REZONING & PLANNED DEVELOPMENT DISTRICT (PDD)

AMENDMENT & SITE PLAN APPLICATIONS

8/14/23 Plan Commission Meeting

Village Planner Report

AS101

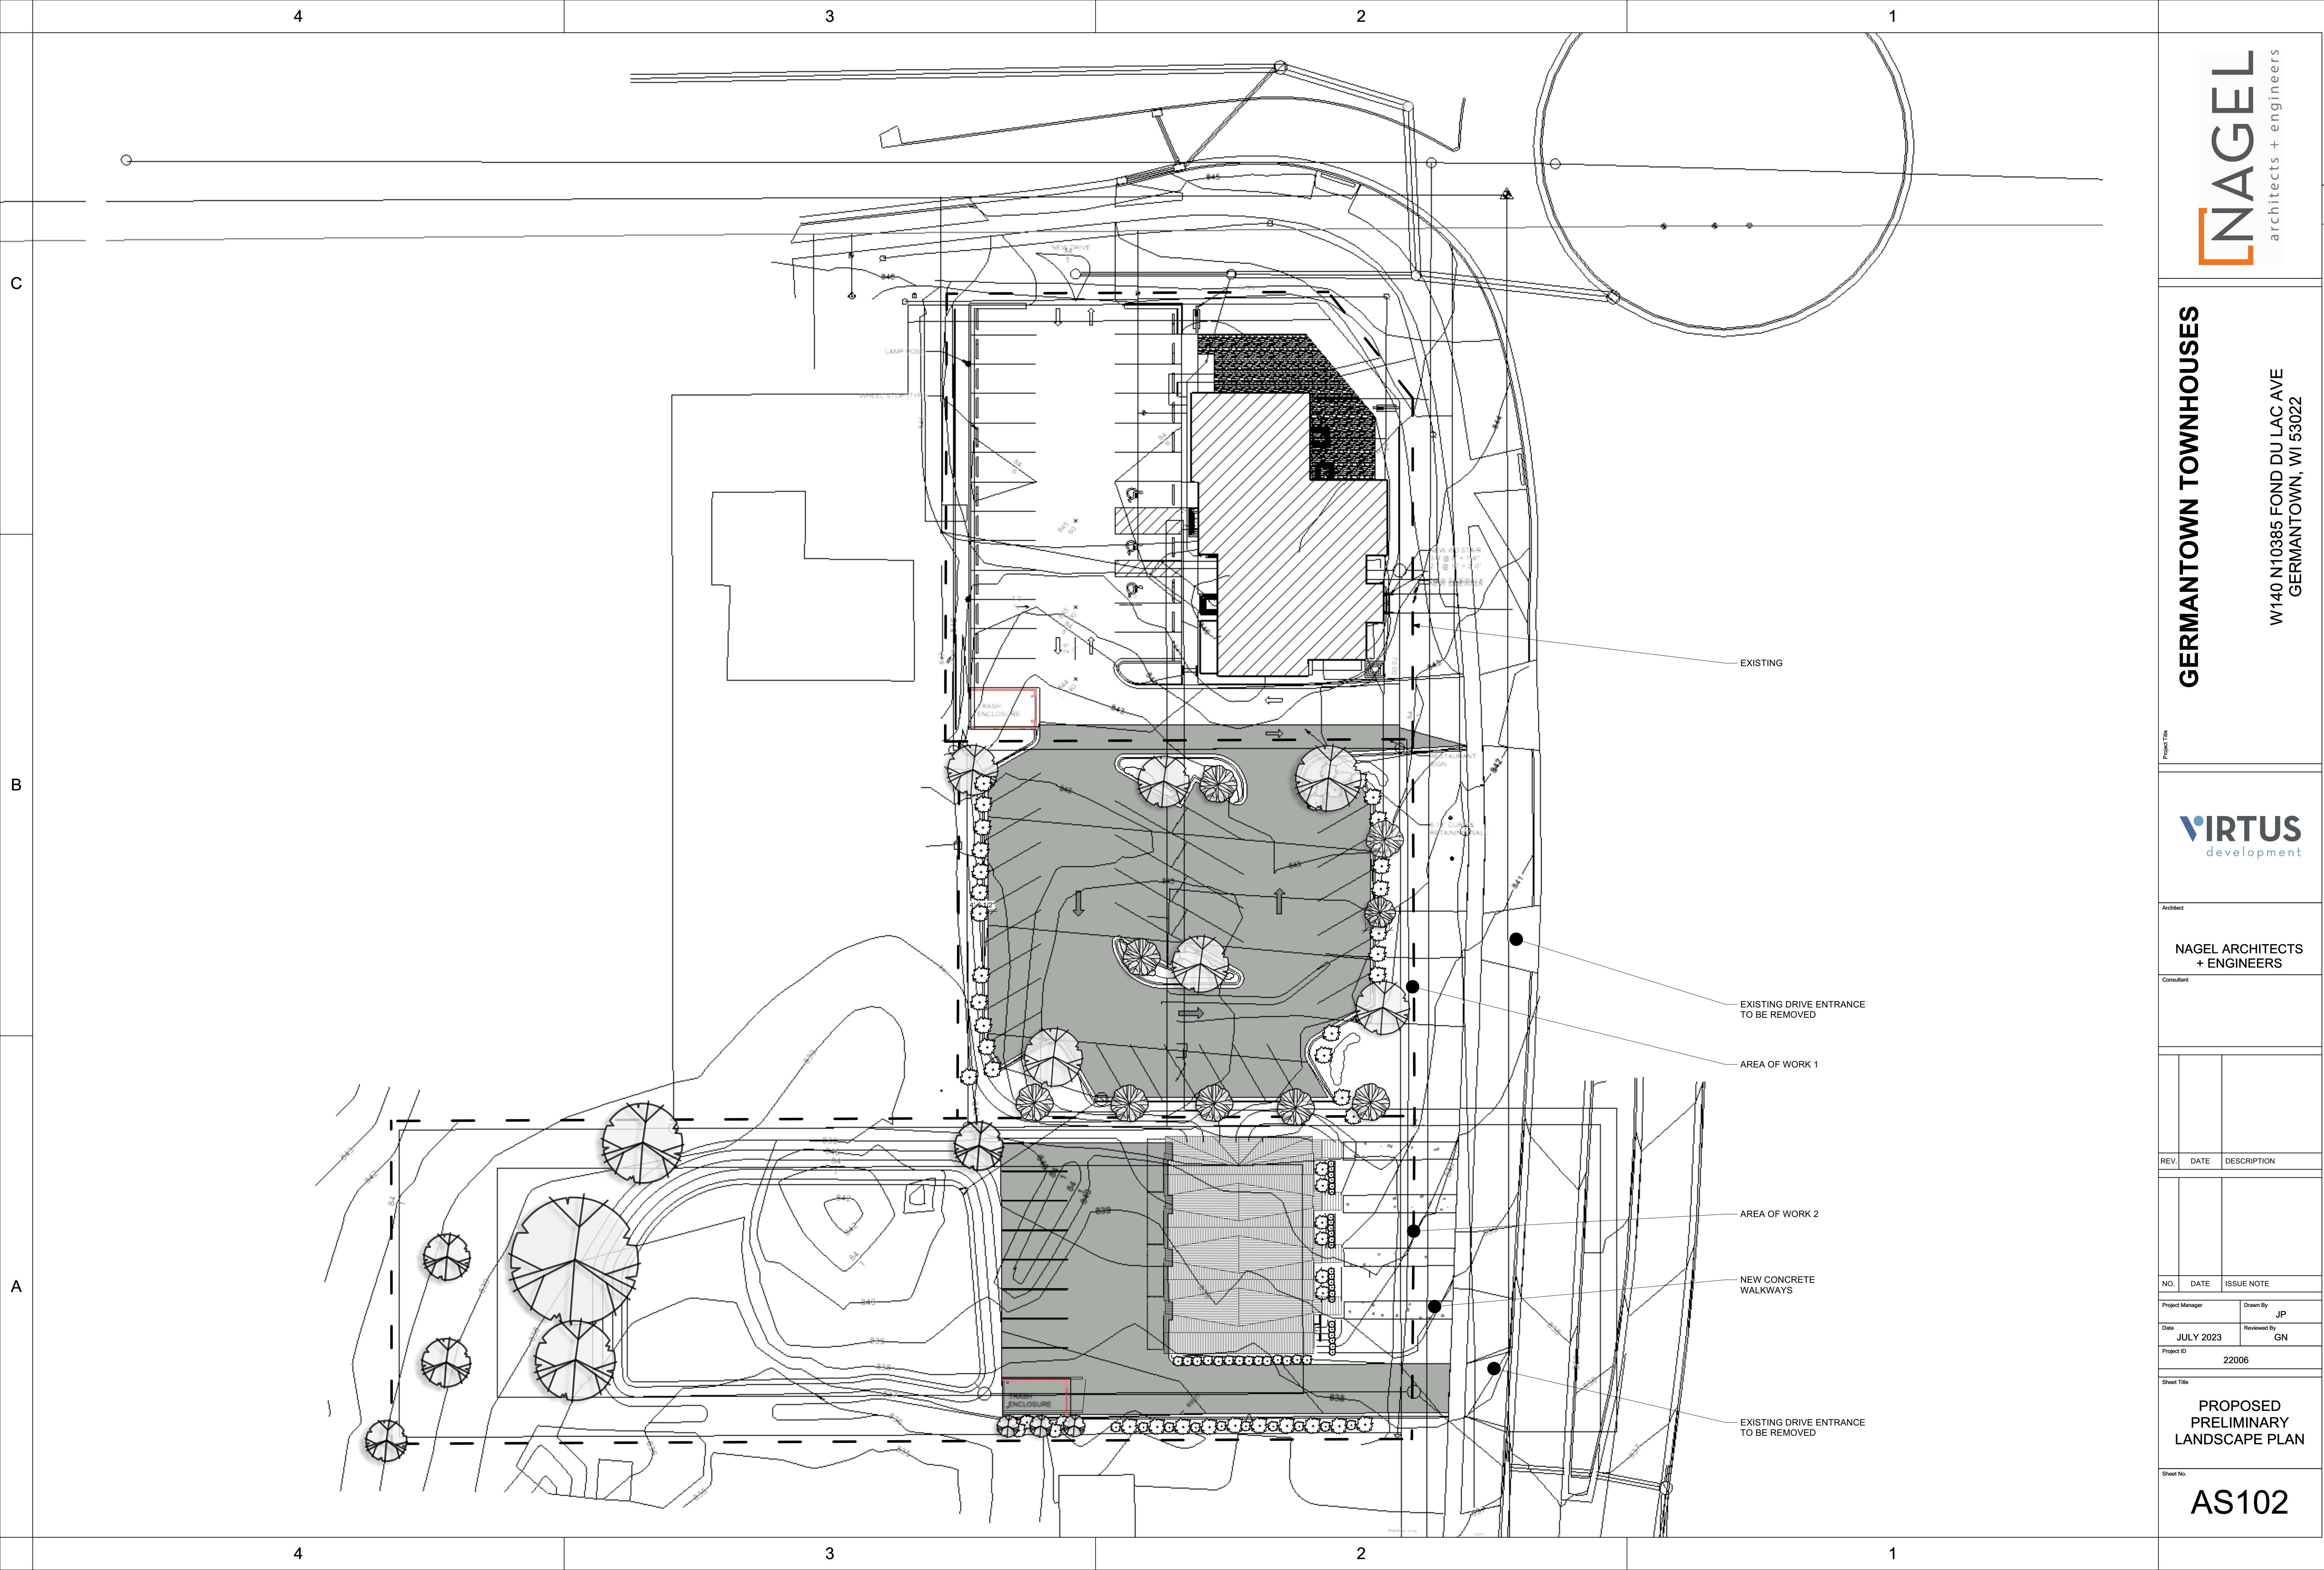
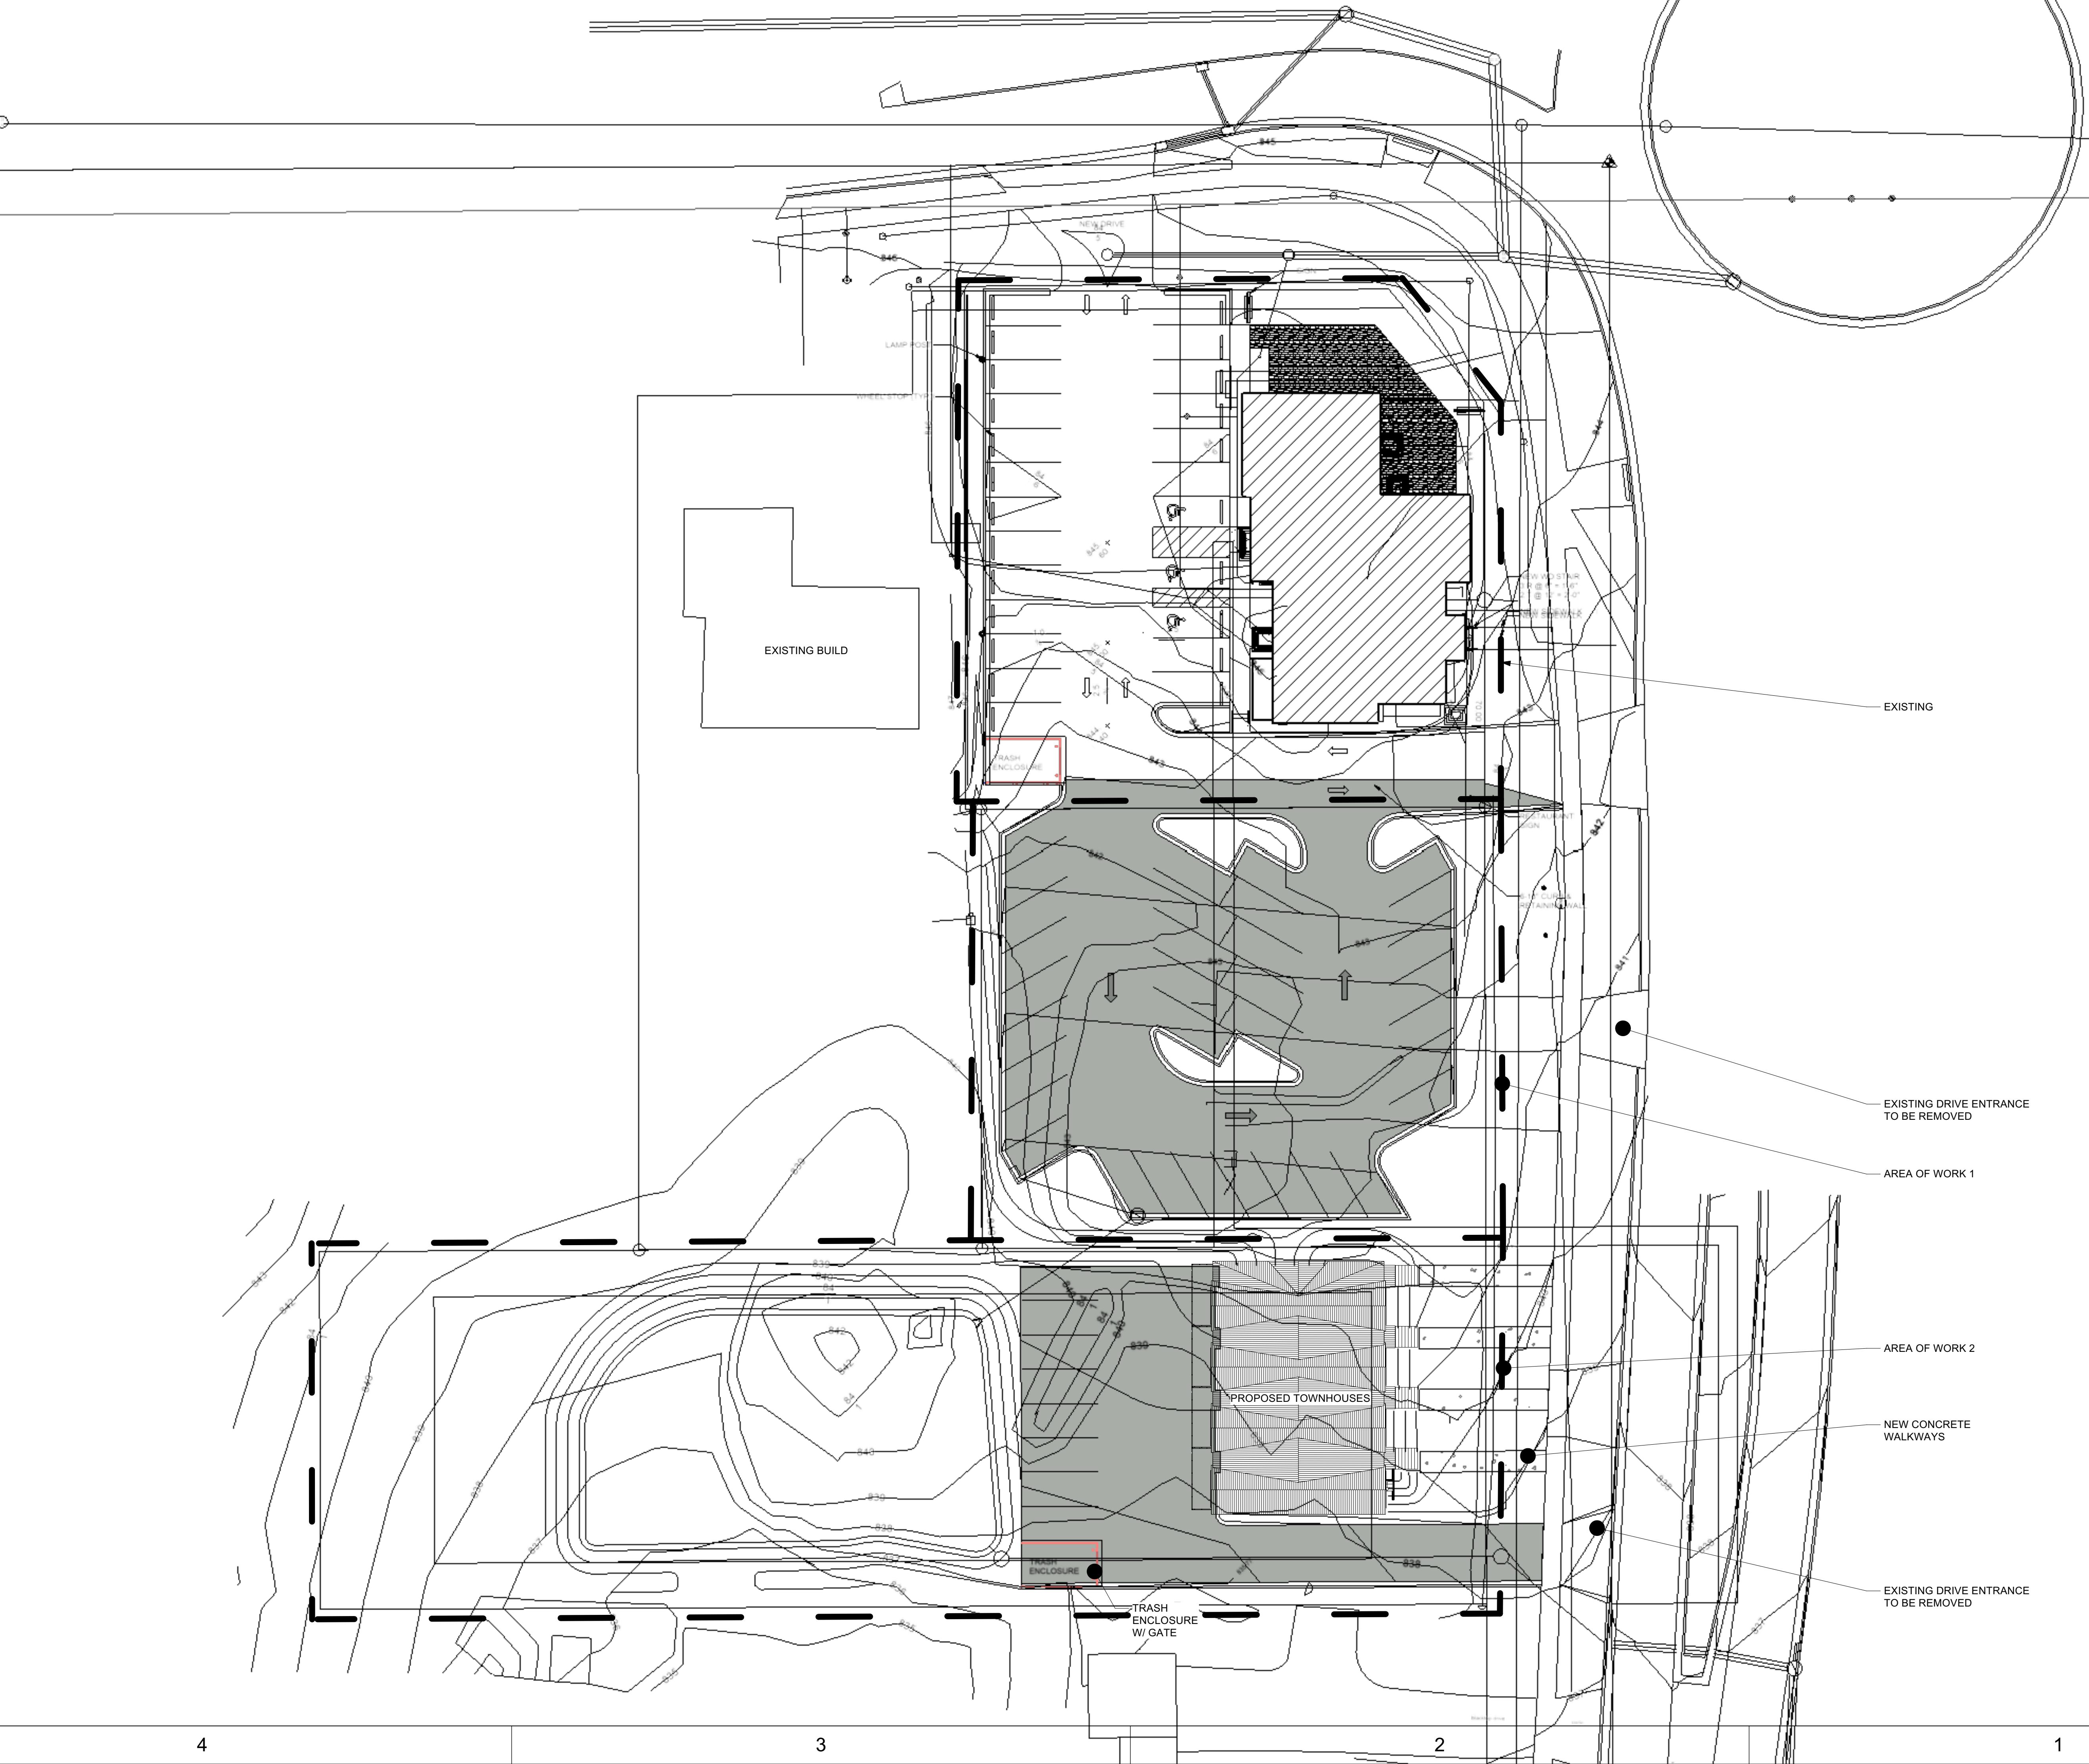
As shown on Sheet C1.02, the proposed setback from the townhouse building to the north property line (proposed parking lot property line) is only 5 feet. Again, a building setback of only 5 from the property (an additional 7 feet to the parking lot pavement edge) leaves little space to provide an adequate landscape buffer to the proposed commercial parking lot serving the proposed renovated restaurant (existing bar).

The Developer is strongly encouraged to consider reducing the size of the parking lot by eliminating the (7) stalls along the south side (closest to the townhouse building) and reconfiguring the two parcels by reducing the size of the parking lot parcel and increasing the size of the townhouse parcel. Since a CSM is required anyway to attach the parking to the retail building parcel, more land could be added to the townhouse parcel to allow the building to be shifted 10-15 feet north to allow more building and driveway setback (and more landscaping buffer and/or fencing) between the townhouse and the single-family property to the south. Doing so could also create more separation between the townhouse and the parking stalls to the north.

8. *Clarify what is being proposed. Is work on the north parcel proposed? Plans are not clear.*
9. *Sheet AS101 does not match the site layout shown on the other plans.*

2. Site Plan approval is subject to creation of the "Kuhberg District" Planned Development District as proposed by Victory Center LLC.
3. The Developer shall reduce the size of the commercial parking lot by eliminating or reconfiguring stalls along the south side (closest to the townhouse building) in order to reconfigure the size of the two parcels to allow the townhouse building to be shifted up to 15 feet north. The goal is to create more building and driveway setback (and in turn more landscaping buffer and/or fencing) between the townhouse and the single-family property to the south meeting the following minimum requirement:

C1.06

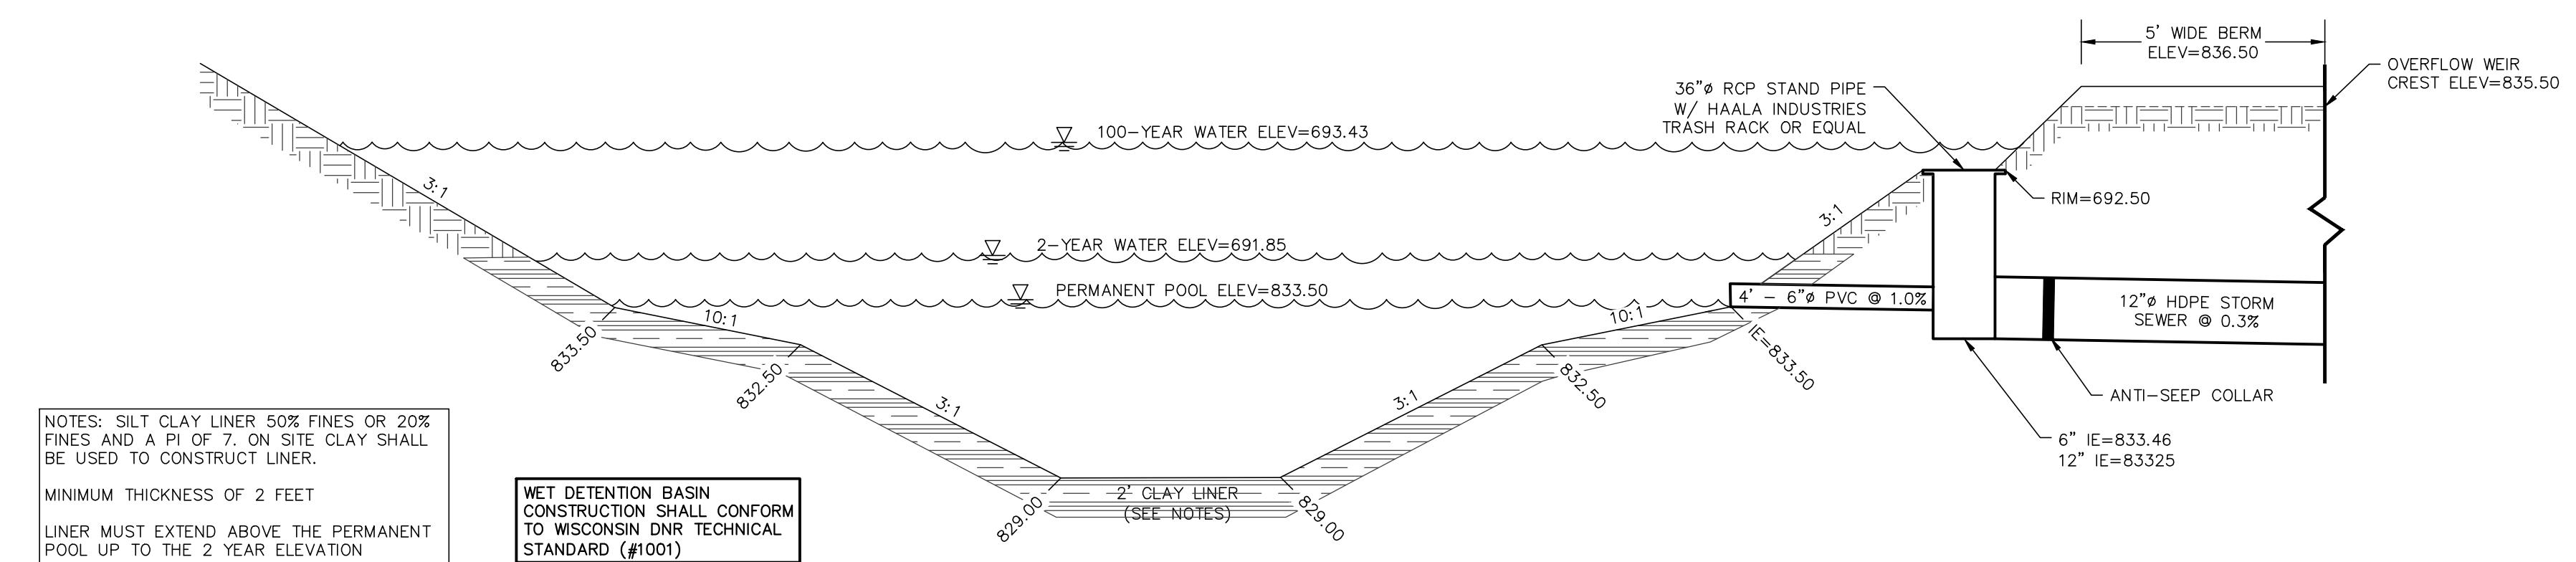
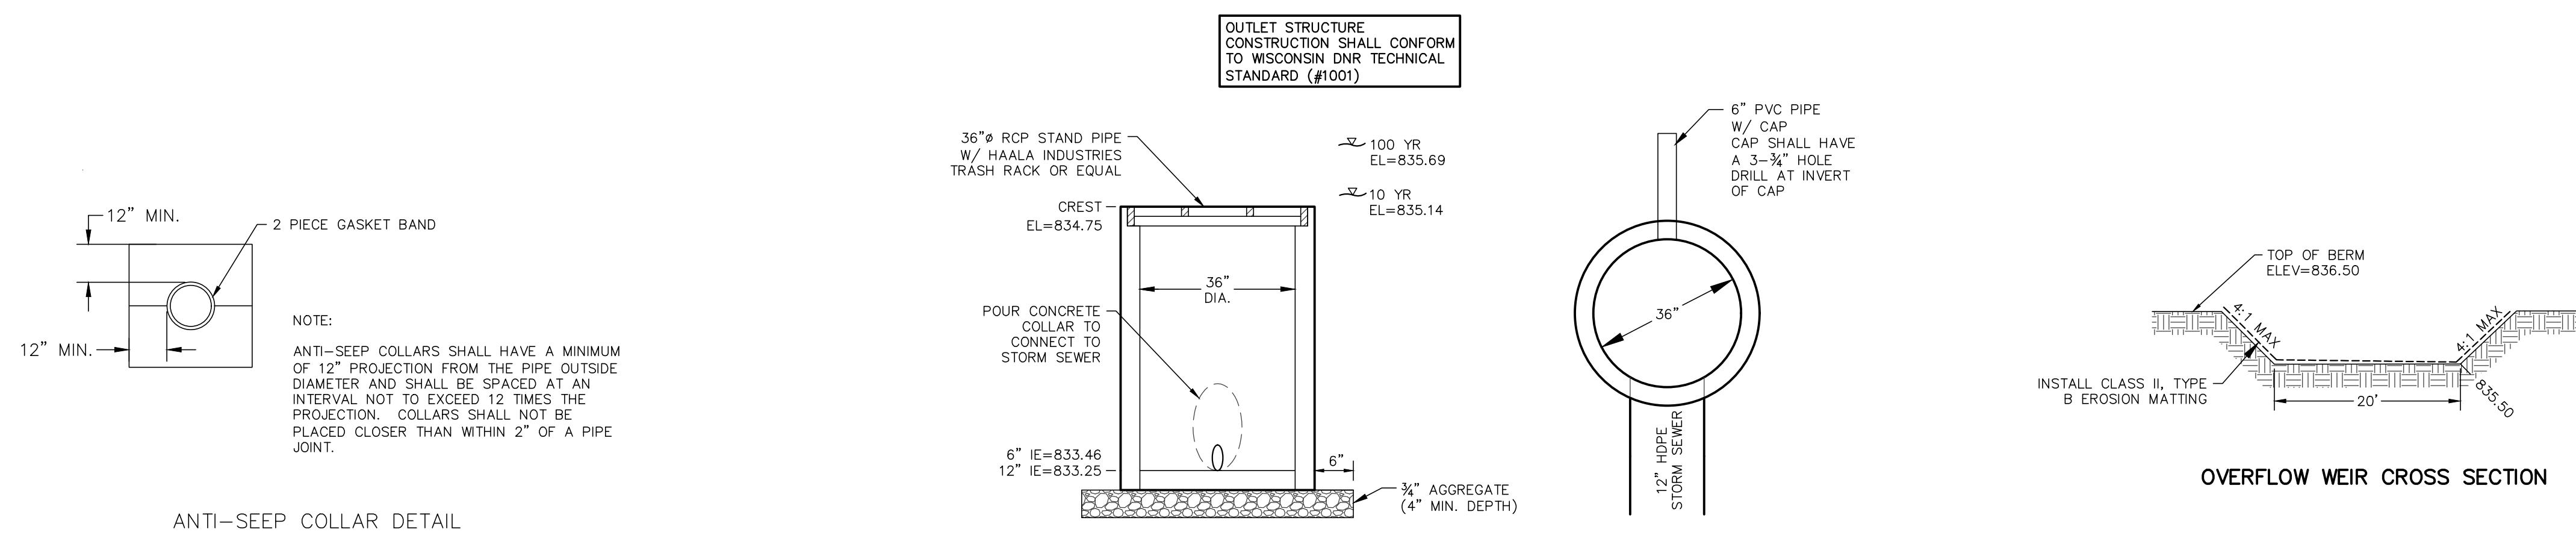
Sheet C1.06
